REVISED RESPONSE TO REQUEST FOR ADDITIONAL INFORMATION

APR1400 Design Certification

Docket No. 52-046

RAI No.: 356-7881
SRP Section: 07 – Instrumentation and Controls – Overview of Review Process
Application Section: 7.0
Date of RAI Issue: 01/04/2016

Figure 7.7-14 I&C System Architecture for the RCC Panel

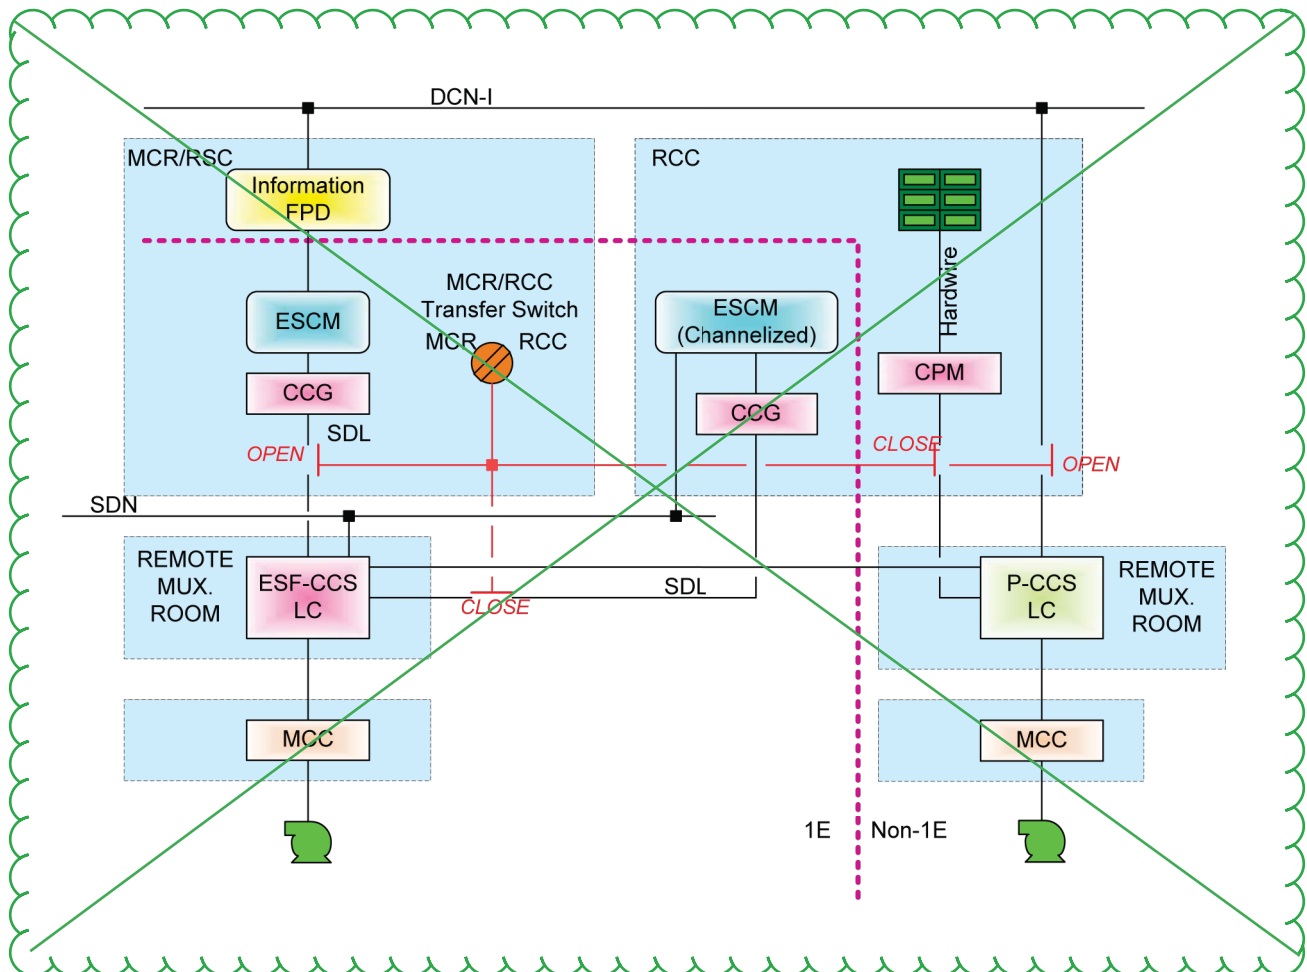
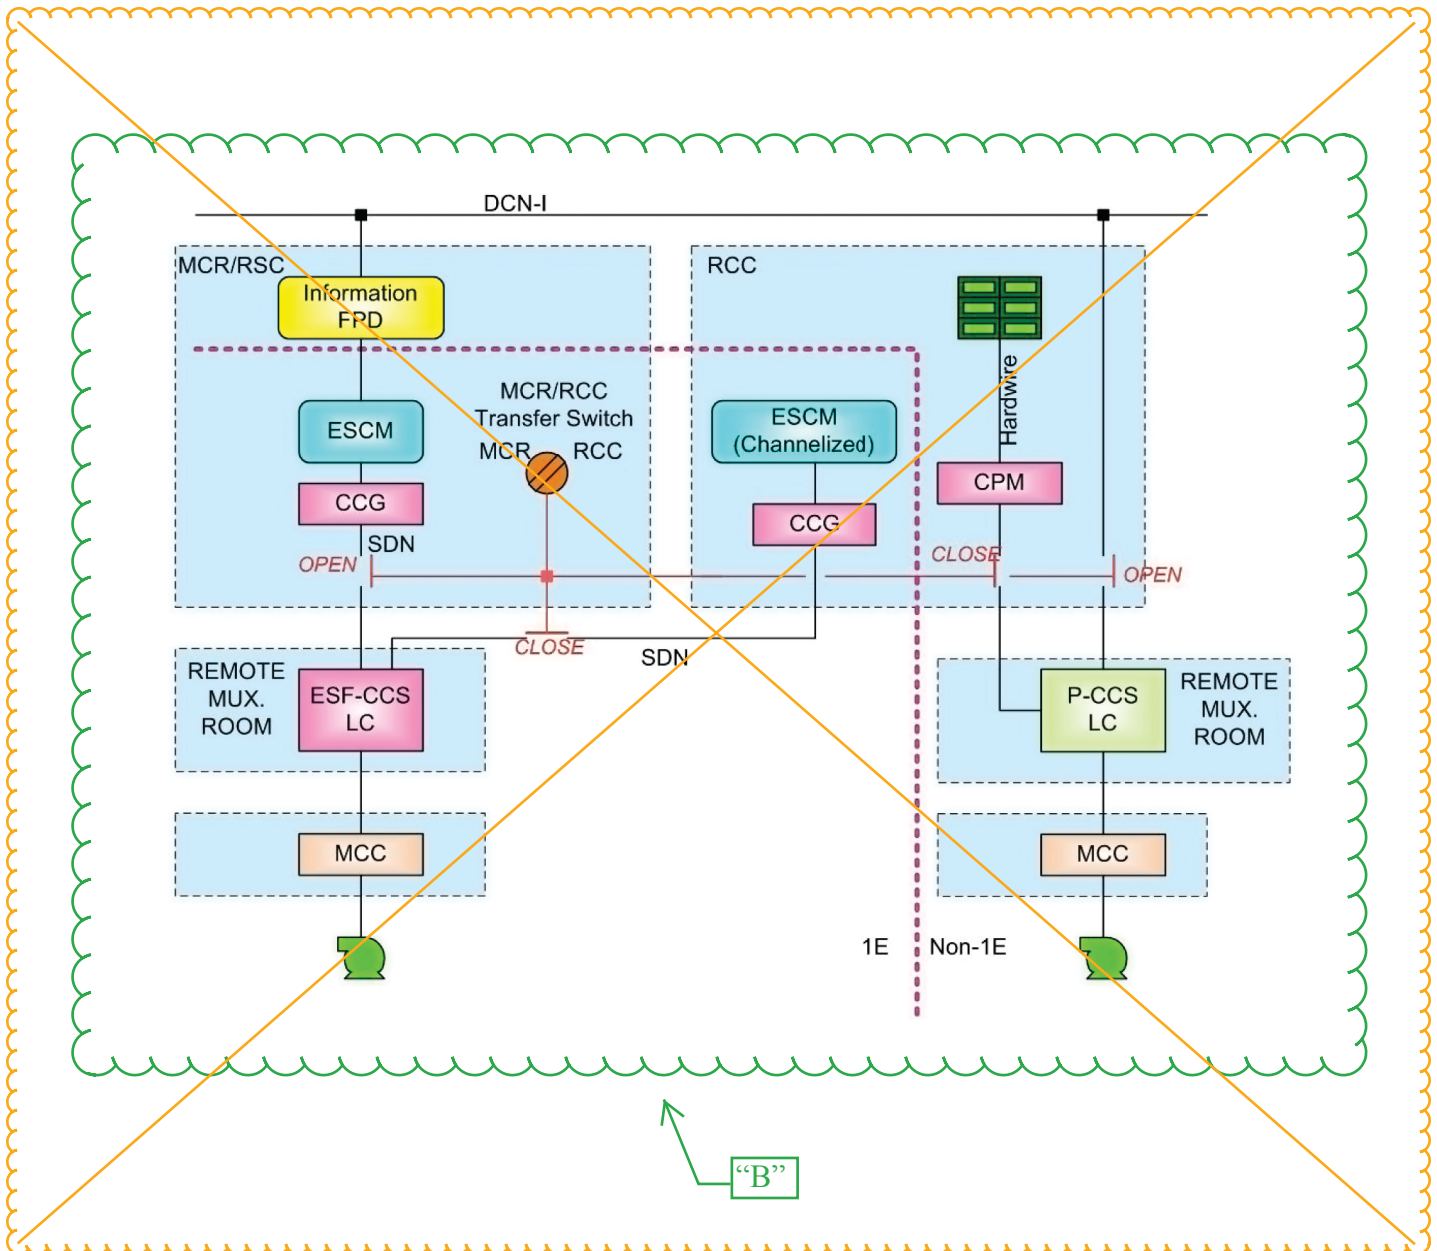
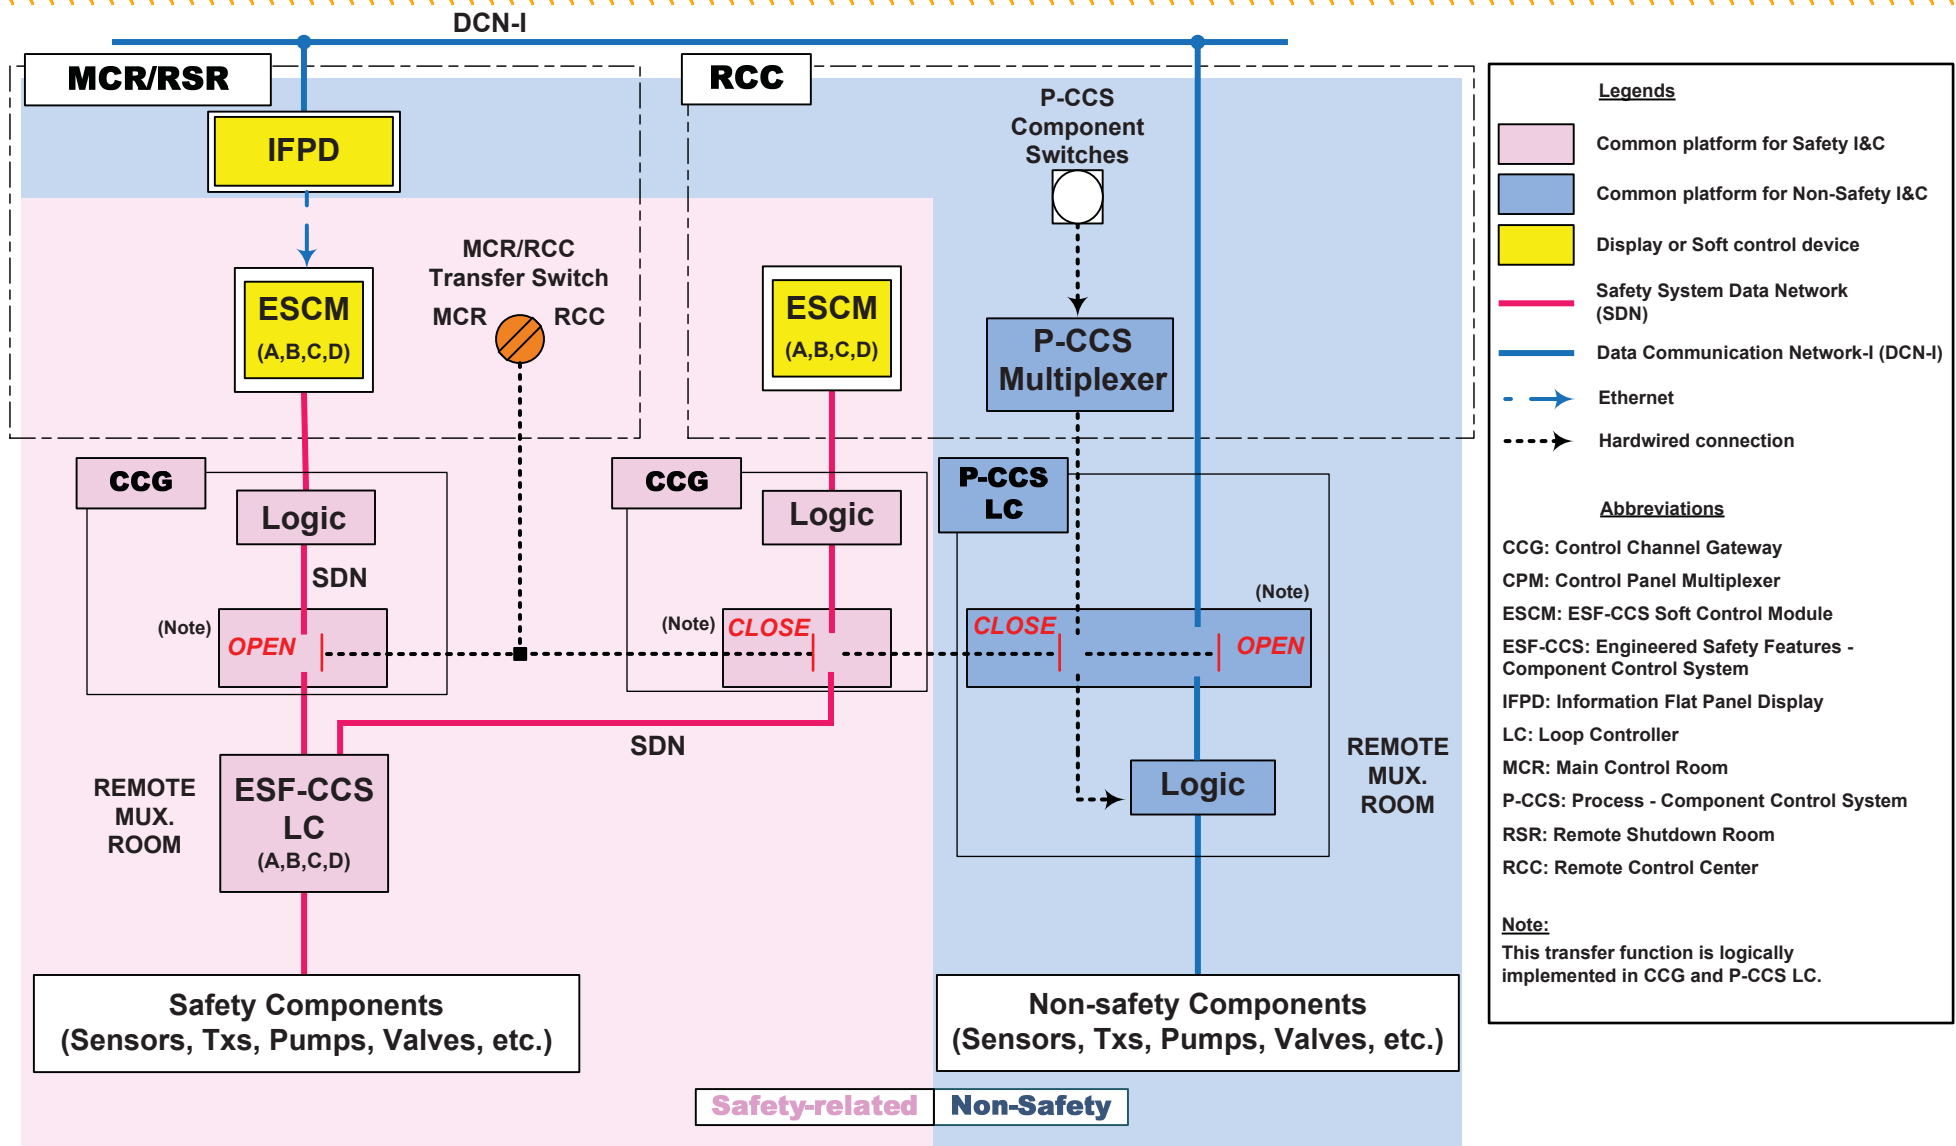
The applicant mentions that the RCC has safety and non-safety related controls available but does not state that RCC complies with any other applicable requirements for this configuration such as independence. The RCC is not depicted on Figure 7.1-1, "APR1400 I&C System Overview Architecture," therefore, there is no physical depiction of how the functionality of the RCC is taken into account within the overall I&C architecture or how its implemented. The acronym for the remote control center is also not defined in the acronym and abbreviation list in Section 7.0 of FSAR Tier 2. It cannot be determined what the difference is between the RCC and RSR.

1. Describe the RCC including all instrumentation, controls, and displays available at the RCC, all communications and architectural details used to implement the RCC, how the RCC addresses all the applicable requirements to the RCC (i.e. Independence), the specific design functions the RCC is intended to meet, the locations of RCC equipment (i.e. I&C cabinets, if applicable).
2. What is the difference between the RCC and the RSR?
3. Have the controls and displays available at the RCC been designed using the human factors engineering process as described in Chapter 18?

DCD Tier 2, Section 7.0, Section 7.7.1.1, Figure 7.1-1, APR1400-Z-J-NR-14001-P/NP, Rev. 0, "Safety I&C System," Figure 4-1, and APR1400-Z-J-NR-14002-P/NP, Rev. 0, "Diversity and Defense in Depth," Figure 4-1 will be revised. The depiction of the I&C architecture of the RCC will be added as Figure 7.7-14. DCD Tier 1, Section 2.5.4.1 will be revised to show that the ESCMs on the MCR, RSR, and RCC have same design features, as indicated in the attachment associated with this response.

- The I&C system architecture for the RCC panel is shown in Figure 7.7-14.
